**SERVICE BULLETIN**

SB No. 99 Issue No. 3

INSPECTION AND RECTIFICATION OF RUDDER PEDAL SLIDERS

Within next 50 flying hours and at each subsequent 50 flying hours until Mod M704B invoked.

FIG 1

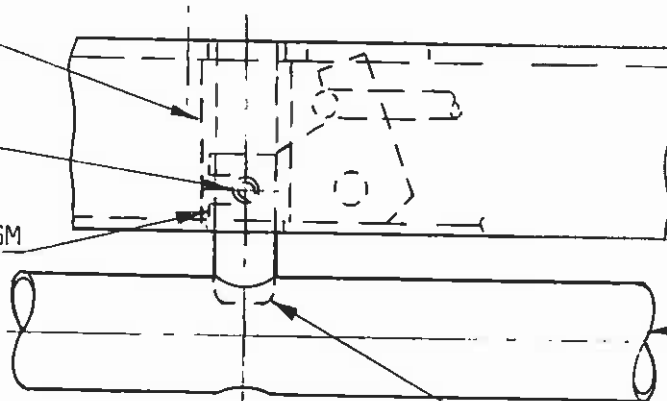
1. Remove each pedal/slider assembly and inspect for:
 - i) Correct operation of adjusting pin lifting mechanism, ie roll pin is engaged in fork, and for looseness of bush, ref Fig. 1.
 - ii) Check for any play in upper slider to lower slider attachment rivets, ref Fig. 2.
 - iii) Check for any play in adjusting mechanism attachment rivets, ref Fig. 3.

4. Modification Procedure:
 - 4.1 Remove pedal pad from slider mechanism.
 - 4.2 Addition of adjusting pin retaining bush anti turn rivet. Fig. 1.
 - 4.2.1 Ensure adjusting mechanism is aligned and is functioning correctly, with roll pin fully engaged in lifting mechanism fork.

- 4.2.2 Position jig JT67G-45-227 onto upper slider, jig will only fit correctly one way.
 - 4.2.3 Drill 2.85mm dia (No.33 drill) 8mm deep hole. Fig. 1, Section A-A.

- 4.2.4 Remove jig and csk 120° x 5mm dia.
 - 4.2.5 Using pop rivet gun fit pop rivet 126-24-031 (Tucker TLP/K319BS).
 - i) Ensure head is flush with surface of slider or up to a maximum of .2mm below surface.

- ii) Ensure adjusting pin and mechanism operate freely.
 - 4.3 Upper slider to lower slider attachment rivets.

FIG 2
UPPER SLIDER-TO LOWER SLIDER, PEDAL MECHANISM JOINT

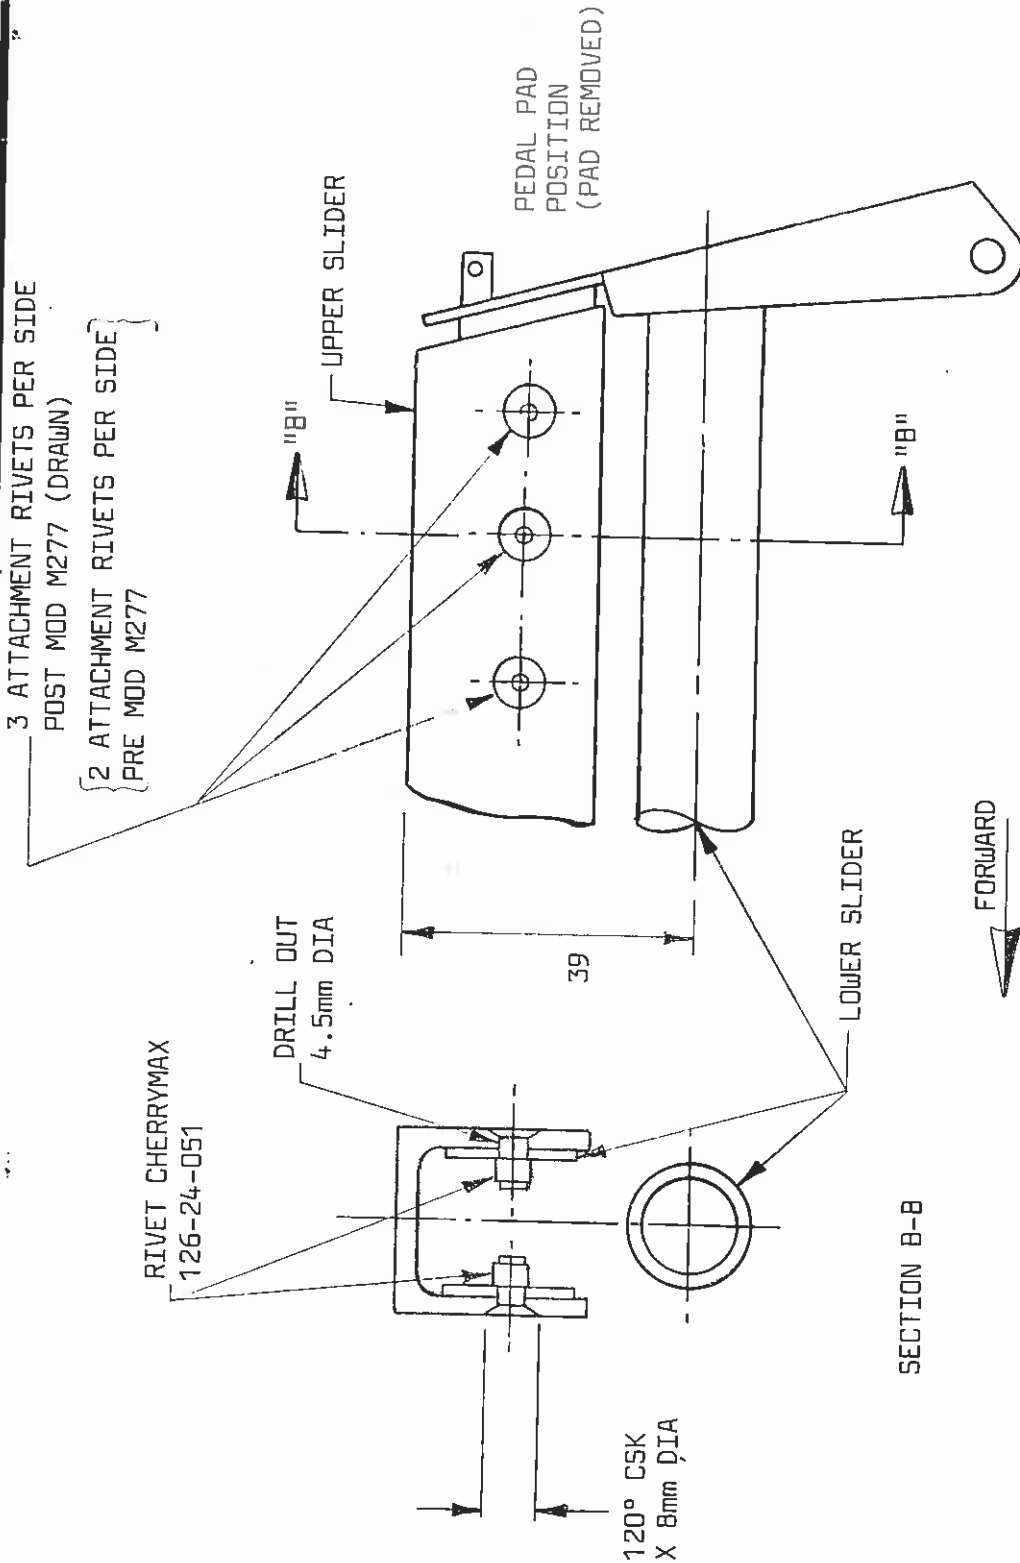
- 2) On Post Mod M277 aircraft there are 6 attaching rivets in total. Replace rivets in accordance with the following sequence:

Drill out forward rivet one side and re-rivet, followed by diagonally opposite aft rivet, re-rivet. Repeat with opposite forward and aft rivets. Finally centre rivet one side then opposite side centre.

- 4.3.1 Drill out existing rivets using 4mm dia drill. Ensure drill does not penetrate too far into slider assy.

- 4.3.2 Drill hole out to 4.5mm dia oversize and csk 120° x 8mm dia (1mm deep).

Prior to rivetting ensure upper slider is parallel (Ref 39mm dimension) to and in line with lower slider, and that the rivet head will be flush or up to a maximum of .2mm below surface.

- 4.3.3 Rivet using suitable Cherry Max Rivet gun and rivet 126-24-051 (Cherry CR 3556P-5-3).

- 4.3.4 After rivetting check alignment and rivets for flushness. Rectify as necessary.

FIG 3
ADJUSTING MECHANISM ATTACHMENT TO SLIDER

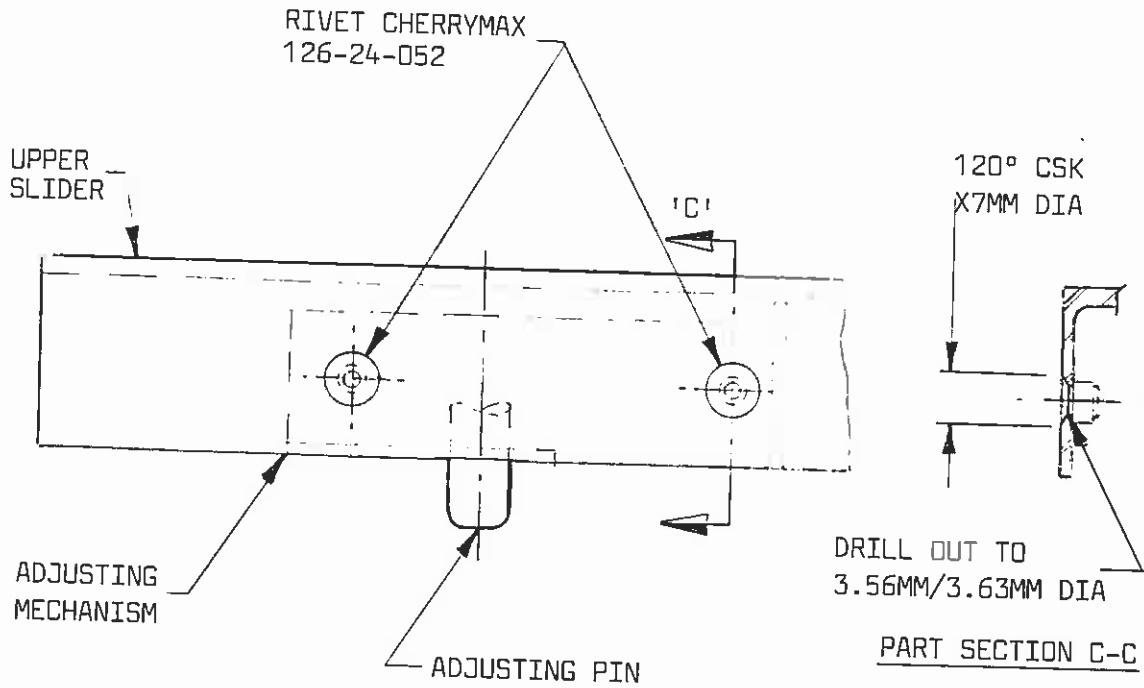
- 4.4 Adjusting mechanism attachment rivets, ref Fig. 3.

Note: Replace rivets in accordance with the following sequence:

Drill out forward rivet one side and re-rivet, followed by diagonally opposite rivet etc.

- 4.4.1 Drill out existing rivets using 3mm dia drill. Ensure drill does not penetrate too far into slider assy.

4.4.2 Drill hole out to 3.6mm dia oversize and csk 120° x 7mm dia (1mm deep).

Prior to rivetting ensure mechanism (both fixed and moving) does not protrude below slider and that the rivet head will be flush or up to a maximum of .2mm below slider surface.

4.4.3 Rivet using suitable cherry max rivet gun and rivet 126-24-052 (Cherry CR3556-4-02).

4.4.4 After rivetting, check correct functioning of mechanism, that mechanism does not foul nylon sliders and that rivets are flush ref note at paragraph 4.4.2.
